# SERVICE LETTER

No. 532

Piper Aircraft Corporation

Subject: Voltage Regulation Component Grounding

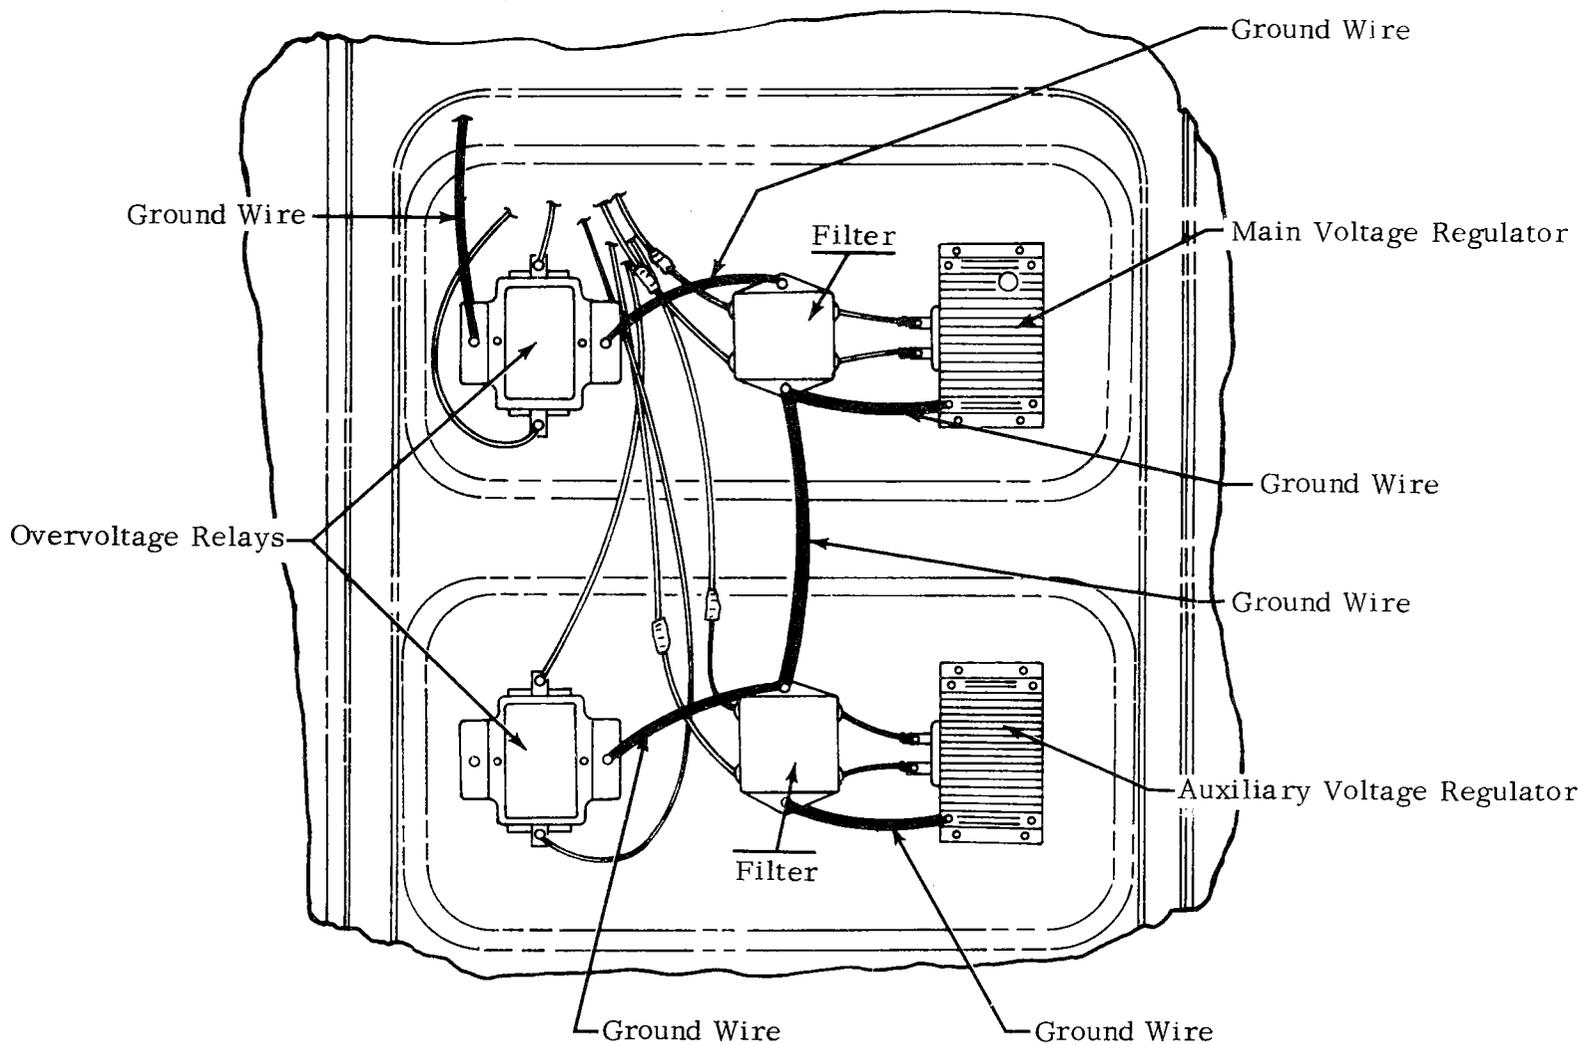
Purpose: To provide a supplemental method of grounding the aircraft voltage regulation system components to the aircraft structure. See sketch attached to this letter for general information.

This Sketch represents the Aztec "D" Voltage Regulation Component Grounding Modification, and is similar to the modification required for affected PA-30 and PA-31 aircraft.

Instructions: Contained in Kits No. 760 331 (PA-23-250 six place Aztec "D"), 760 332 (PA-30 Twin Comanche "C") and 760 333 (PA-31 and PA-31-300 Navajo) Voltage Regulation Component Grounding Installation

Detailed Sketches relative to the above referenced aircraft are contained in the applicable Voltage Regulation Component Installation Kits, specified on the Service Letter.
